American Telecommunications Certification Body Inc.
6731 Whittier Ave, McLean, VA 22101

RE: Kyocera Wireless Corp.

FCC ID: OVFKWC-K24B

After a review of the submitted information, I have a few comments on the above referenced Application. Depending on your responses, kindly understand there may be additional comments.

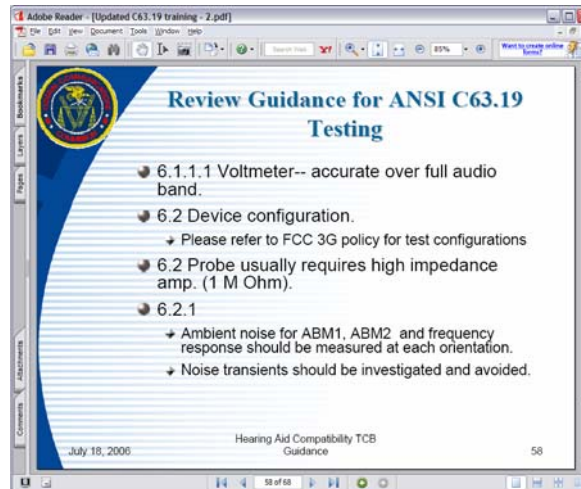
- 11) Page 41 does not define the worse case channel reported as implied.

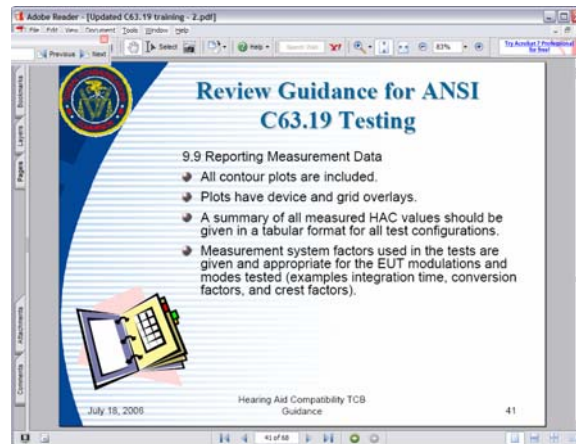
- 12) Although ANSI C63.19 7.3.2 asks only for the axial frequency response, the FCC appears to desire all 3 orientations to be measured (see below). This appears to be for the Validation setup. However given limits are specified in section 7.3.2 are only specified for axial, we have a pending question with the FCC in effort to confirm this issue.

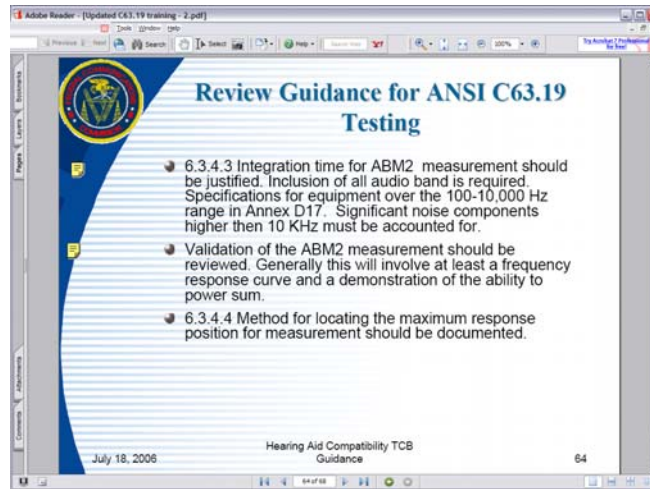
- 16) Volume setting should be documented.
- 17) It is uncertain if a sine wave or P.50 test signal was used. If a sine wave signal was used, it is uncertain how the voice coder will handle it (i.e. assurance that it will pass CW correctly). Also some base station simulators require a special vocoder calibration. If so, calibration details should be provided and clear. If a P.50 signal was used, this generally requires integration over time because of the variation of amplitude over time. Information regarding proper time lengths should be provided.
- 18) Use of multiple signal types for the different measurements should be clearly documented and justified. Example 1 KHz CW for ABM1 per 6.3 procedure, and P50 for frequency response per 6.4. Currently the specific signal types actually used (vs. a generic procedure) could not be determined.

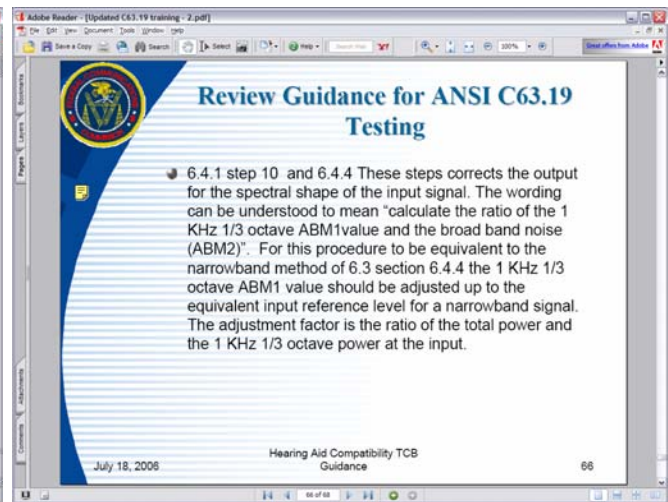
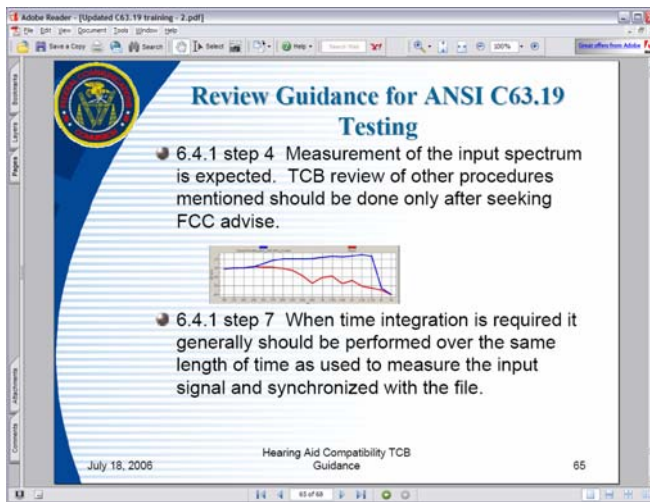
- 19) For ABM2 measurements, please justify integration times used and ensure inclusion of the whole audio band. Additionally, please help address the FCC's concern with "demonstration of the ability to power sum as cited below".

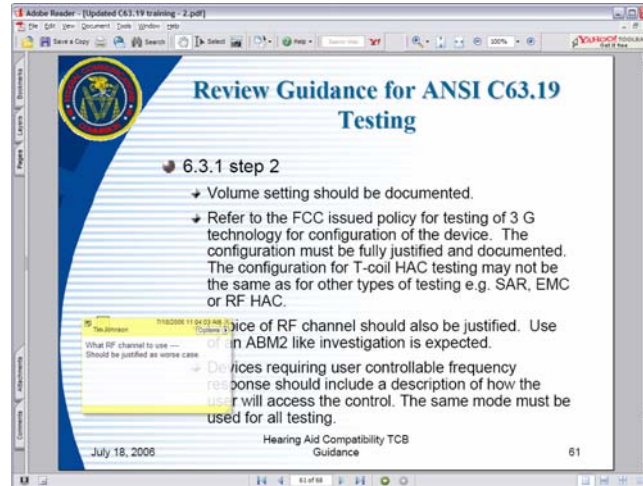
- 20) It is uncertain if measurements under section 6.4 were used. If so, the FCC has specific concerns, such as the input should be directly measured (FCC Desires measured, not calculated). If not we are told we must consult with the FCC for further information. Please explain.
